UNITED STATES PATENT AND TRADEMARK OFFICE

APPLICATION NO.	FILING DATE	FIRST NAMED INVENTOR	ATTORNEY DOCKET NO.	CONFIRMATION NO.
10/648,423	08/25/2003	Edward Kirko	KIE-0002	3997
7590 02/14/2006 CANTOR COLBURN LLP 55 Griffin Road South Bloomfield, CT 06002			EXAMINER MEISLIN, DEBRA S	
			ART UNIT	PAPER NUMBER
			3723

Office Action Summary	Application No. 10/648,423	Applicant(s) KIRKO, EDWARD	
	Examiner Debra S. Meislin	Art Unit 3723

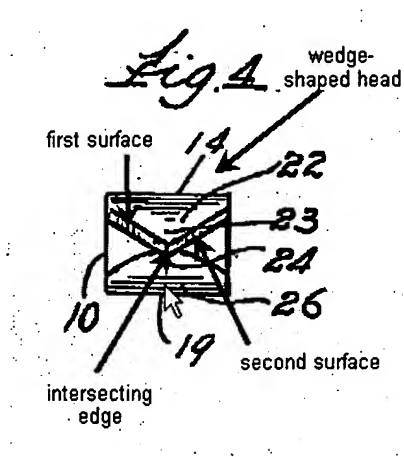
Kaskouras discloses a wedge-shaped head having a first surface, a second surface, and an intersecting edge defined by the first and second surfaces (see figure 4), below:

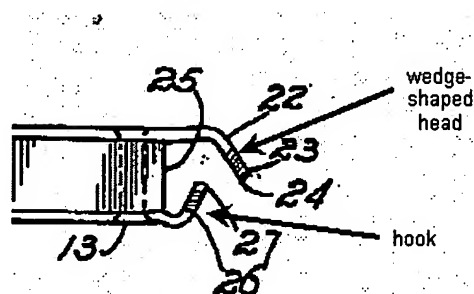
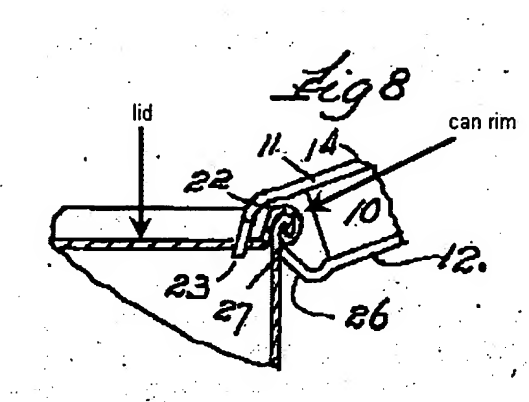
Kaskouras discloses a hook extending from the length of rigid material proximate to the wedge-shaped head, the hook being configured to engage a portion of a rim of a flip-top can such that when the flip-top can opener is pivoted about the portion of the rim, the intersecting edge engages a lid of the can in a manner that substantially removes a portion of the lid of the can disposed between an opening and the rim, wherein a fluid in the can flows through an enlarged opening of the can as shown in figures 2 and 8, below:

A recitation of the intended use of the claimed invention must result in a structural difference between the claimed invention and the prior art in order to patentably distinguish the claimed invention from the prior art. If the prior art structure is capable of performing the intended use, then it meets the claim. Note that the hook of Kaskouras is capable of engaging a "flip-top" can.
